## ***Interactive comment on “Seasonal renewal time variability in the Curonian Lagoon caused by atmospheric and hydrographical forcing” by G. Umgiesser et al.***

**G. Umgiesser et al.**

Received and published: 9 January 2016

**Fig. 1.** river discharge and ice concentration

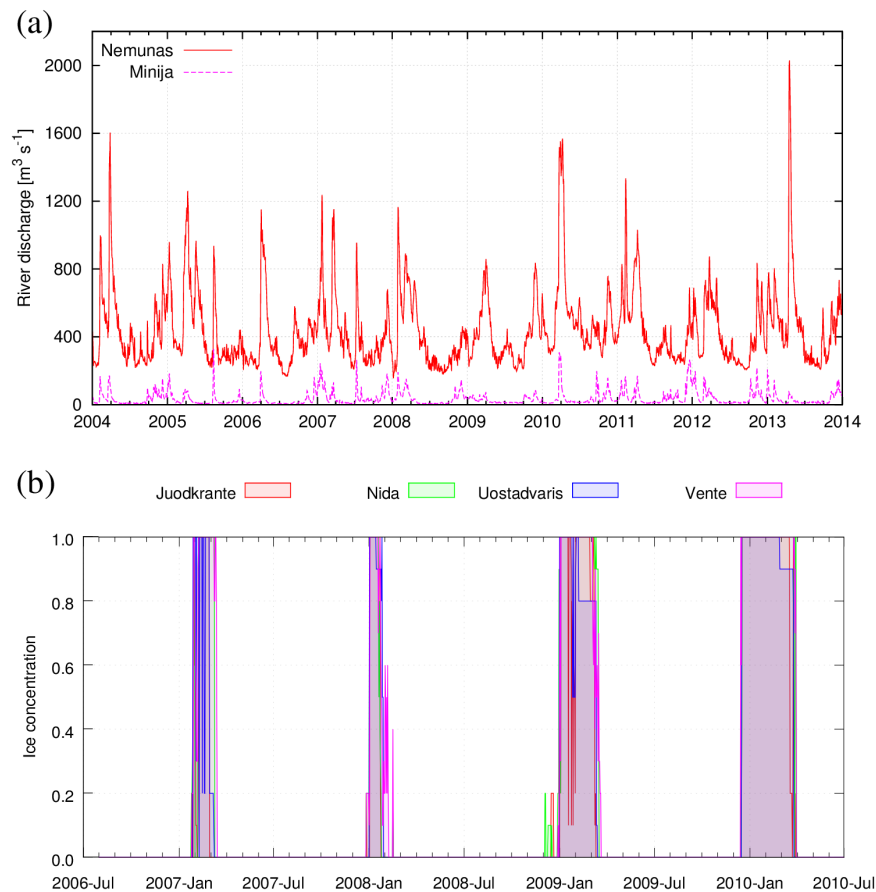
Page 5: List the average discharges of all rivers, even if Nemunas river dominates. A plot of the change in Nemunas discharge with time is necessary to understand its seasonal influence.

Page 12: A plot of the temporal variability of various (especially Namunas) river discharges is essential to understand the results in Figures 4 and 5.

Answer: we will list the discharge of all rivers and will insert a plot of the Nemunas discharge in the lagoon.

Answer: we have included a plot of the various river discharges over the 10 years.
